SERVICE BULLETIN AMATEUR RADIO

SUBJECT	DATE
TW-4100A REPEATER STOP SCAN ON THE UHF BAND	12-17-87

FIGURE 1

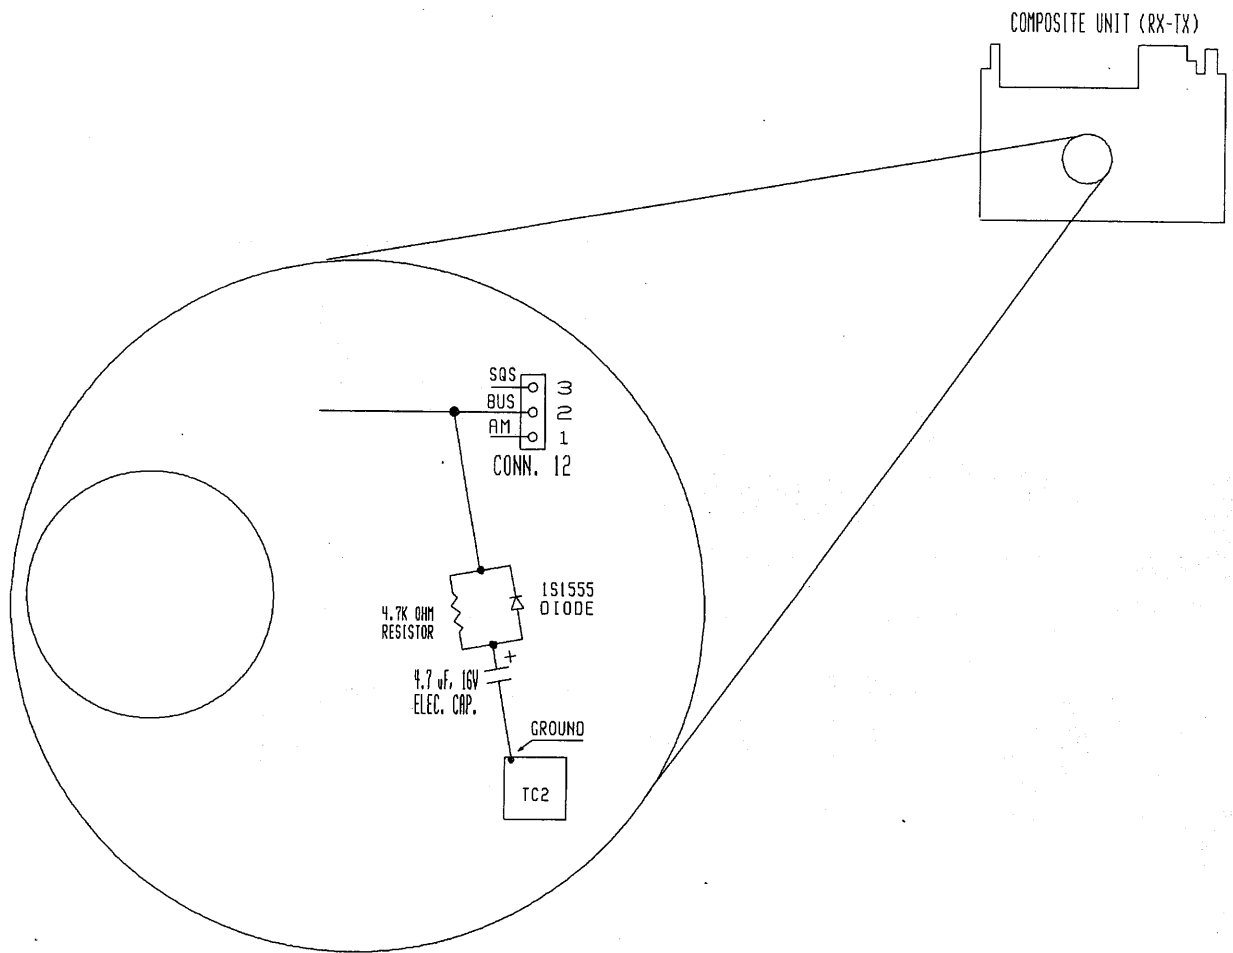
During repeater cross band operation, the TW-4100A may not detect a UHF signal while it is alternating between the two bands. This is due to the electric field generated by the strong UHF receiving signal causing the busy circuit to malfunction. The following modification will allow detection of the UHF signal.

Refer to FIGURE 1 for the next 3 steps.

4. Locate connector number 12 on the Composite unit (RX-TX) on the bottom of the transceiver.
5. Carefully strip 1/8 inch of insulation from the wire attached to pin 2 connector 12 approximately 1/4 inch from the connector (do not break the wire).
6. Solder the 3 components (listed above) between the wire and ground. A good ground location is the can around TC2 and L8.
7. Assemble the transceiver by reversing steps 1 - 4.

(1) RESISTOR 4.7K OHM, 1/8th WATT	PART # RD14BB2B472J
(1) CAPACITOR, ELECTROLYTIC 4.7uF, 16V	PART # CE04CW1C4R7M
(1) DIODE 1S1555	PART # V11-0076-05
